SUBDIVISION COMMITTEE
METROPOLITAN AREA PLANNING COMMISSION

STAFF REPORT
(Preliminary Plat)

CASE NUMBER: S/D 94-11 WONG ADDITION

CASE NUMBER: S/D 94-11 WONG 2nd ADDITION

VICINITY MAP:

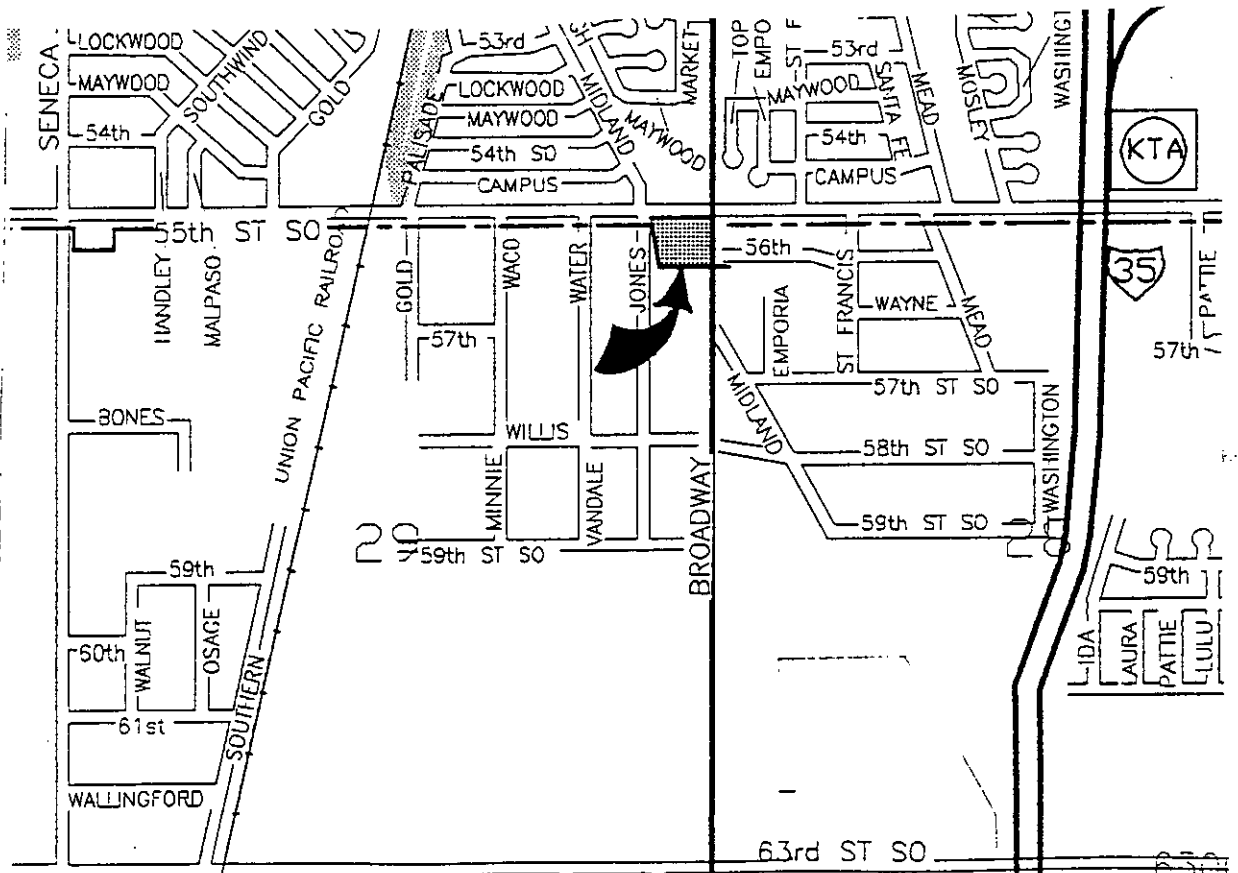
- A. A portion of this site is still within the County. The applicant shall therefore request annexation to Wichita for that portion of the site located in the County. To avoid issues on the proper procedure for having this plat reviewed and approved, this annexation shall be completed before the plat is scheduled for City Council review. Consequently, only Wichita City Council review of the plat will be needed.

- B. The applicant shall guarantee the extension of sanitary sewer to serve the lots being platted. In particular, sewer needs to be extended to proposed Lot 2.

- C. The applicant shall guarantee the abandonment and/or relocation of sanitary sewer lines no longer being covered by a public utility easement.
- D. The applicant shall guarantee the closure of the driveway to 55th Street South located in the area of complete access control.

- G. On the final plat, the word "complete" should be deleted on the face of the plat for the area of access control to Broadway where one opening is being allowed.

- H. The final plat shall also reference the dedication of access controls in the plattor's text.
- I. The applicant is advised that access to Broadway, a State Highway, may be limited or determined by access controls provided for under State requirements.

- J. The applicant is advised that the legal description as shown on the preliminary plat is somewhat ambiguous in regard to "the south 3 feet of Lot 1 and Lot 2," Vandale Addition, etc. That is, the south 3 feet can be interpreted to apply to both lots and not just Lot 1. The description in the platting binder is perhaps more appropriate, i.e., Lot 2 and the south 3 feet of Lot 1, etc.

- M. Prior to or at the time of submitting the final plat, the applicant shall submit a drainage plan to City Engineering for review and approval.

VICINITY MAP:

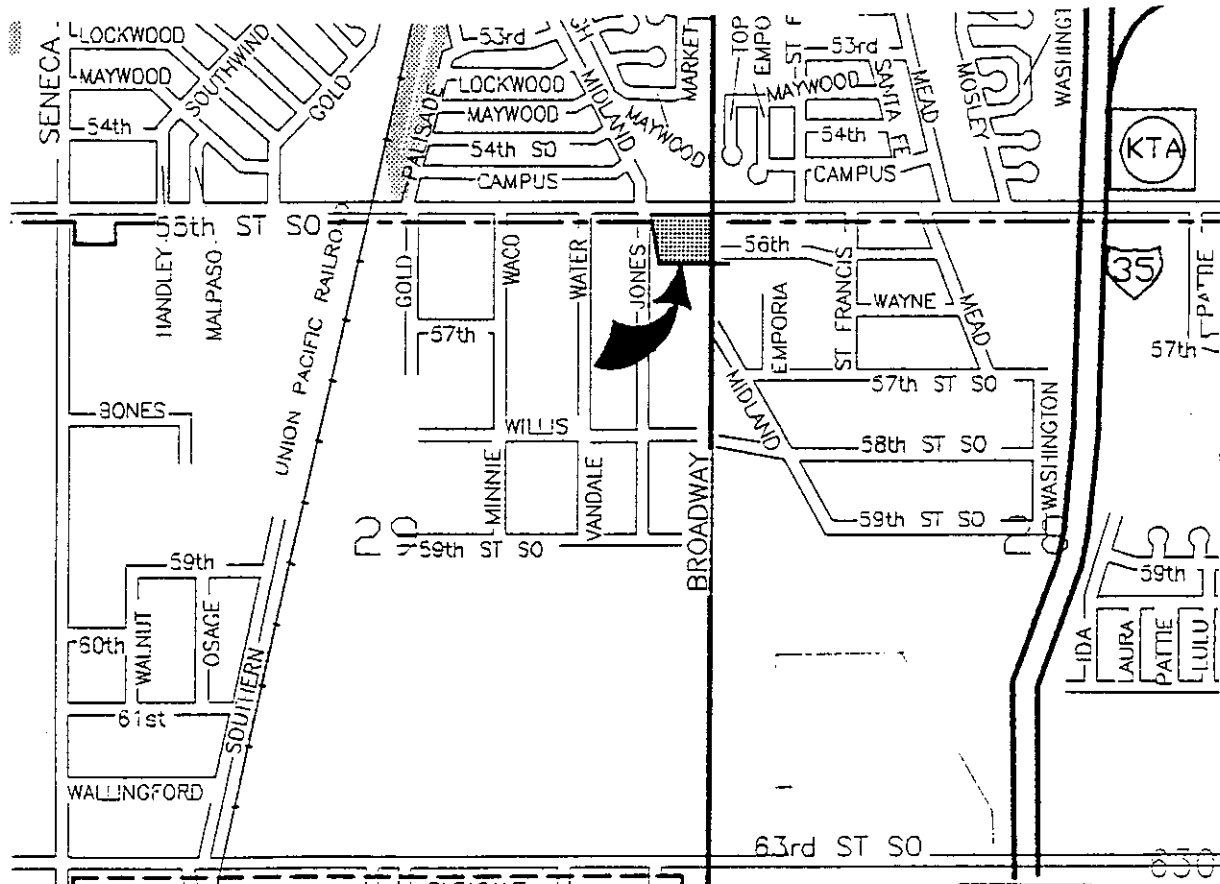
- A. A portion of this site is still within the County. The applicant shall therefore request annexation to Wichita for that portion of the site located in the County. To avoid issues on the proper procedure for having this plat reviewed and approved, this annexation shall be completed before the plat is scheduled for City Council review. Consequently, only Wichita City Council review of the plat will be needed.

- B. The applicant shall guarantee the extension of sanitary sewer to serve the lots being platted. In particular, sewer needs to be extended to proposed Lot 2. Prior to submitting the final plat, the applicant was to meet with City Engineering to determine if additional easement should be granted to provide for the possible extension of sanitary sewer southward. Engineering needs to indicate if any such easement is needed.

- C. The applicant shall guarantee the abandonment and/or relocation of sanitary sewer lines no longer being covered by a public utility easement.
- D. The applicant shall guarantee the closure of the driveway to 55th Street South located in the area of complete access control.

- G. Traffic Engineering needs to comment upon the access controls to Broadway. The preliminary only indicated 1-opening. Now apparently based on the access control involving Broadway as a State Highway, two openings are being noted. However, the State's access controls should not preclude the City's authority to require fewer openings. Engineering, therefore, needs to indicate if this plat should be required to indicate such additional access control, such that one-opening is allowed as originally indicated by the preliminary plat.

- H. On the final plat tracing, the plattor's text shall be amended to indicate that access controls are being dedicated to the "City of Wichita".
- I. The print along the east line of this plat is too small for proper microfilming and shall be shown at an acceptable size on the final plat tracing.

- J. As indicated by the platting binder, the Quik Trip Corp. is indicated as owner of a portion of this site. The final plat must therefore be signed by Quik Trip, but is not now shown on this final plat.
